# UNITED STATES PATENT AND TRADEMARK OFFICE

APPLICATION NO.	FILING DATE	FIRST NAMED INVENTOR	ATTORNEY DOCKET NO.	CONFIRMATION NO.
09/785,087	02/15/2001	Michael L. Reed	REED-1 CONT	7261

## Office Action Summary

## DETAILED ACTION

FIG. 13

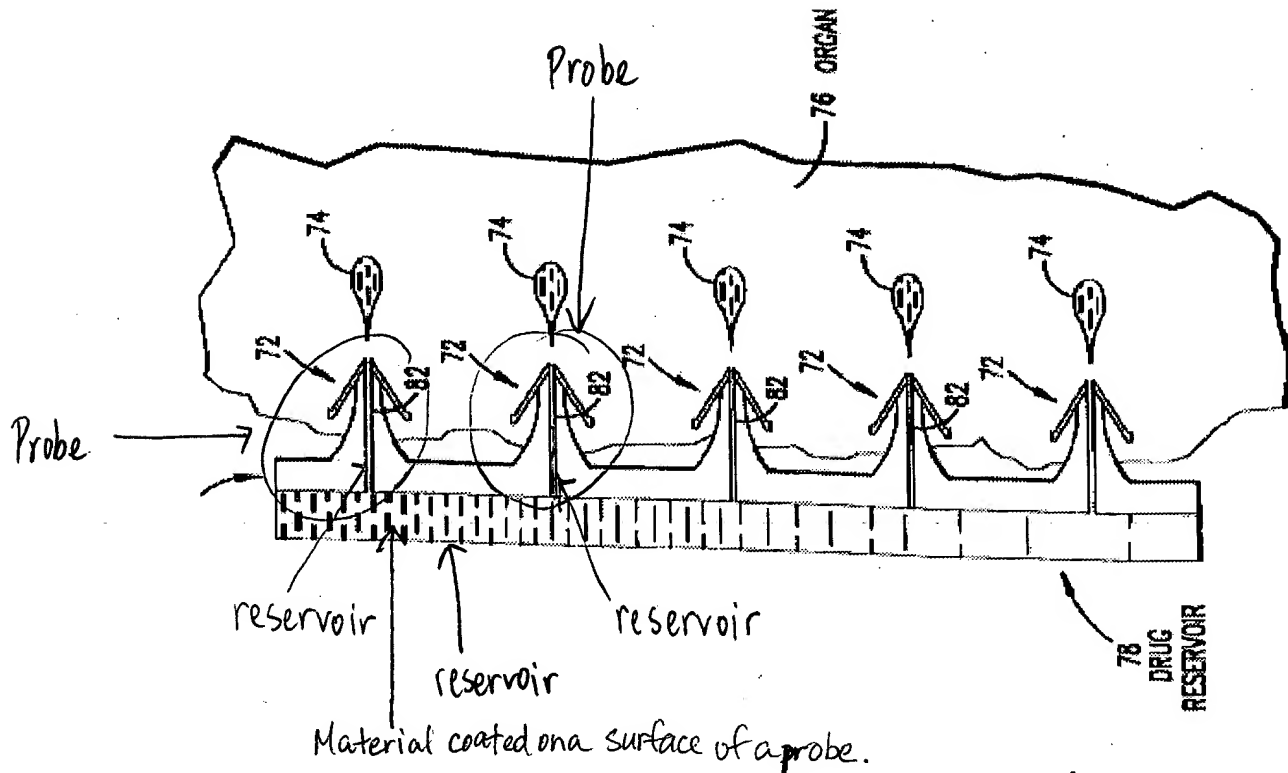
Reed et al discloses an apparatus for treating a vessel of a patient comprising a deployment mechanism adapted to be placed in a vessel, at least one probe disposed on the outer surface, having a porous surface and having one or more micro-miniature reservoirs, and a drug, gene, or therapeutic agent coated on the at least one probe (See figure below).
